ABERT RANCH

PRELIMINARY GRADING & EROSION CONTROL PLAN

SHEET: **C1**

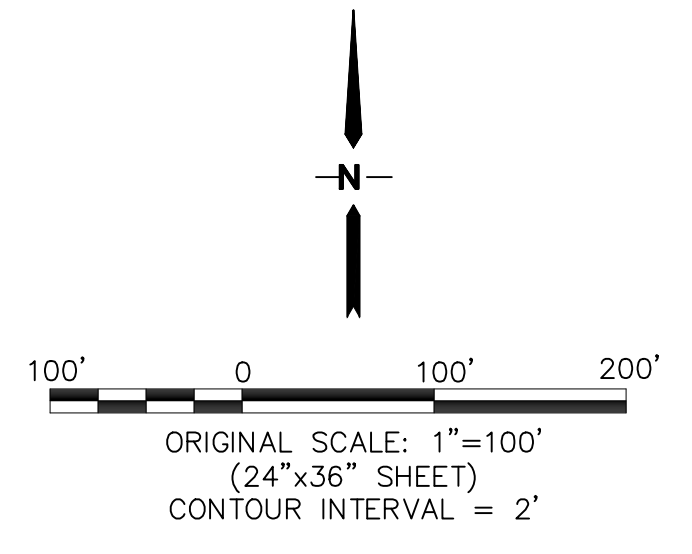
Are you asking for early grading? If so add to the letter of intent and submit a financial issuance form.

Include this area within a drainage easement.

Show the access easement to the detention pond.

Provide a drainage easement for the roadway and offsite basin D12 runoff.

Label and show proposed grading for the temporary emergency access. A culvert is likely required at the access point.

Add: PCD File No.: SP-17-007
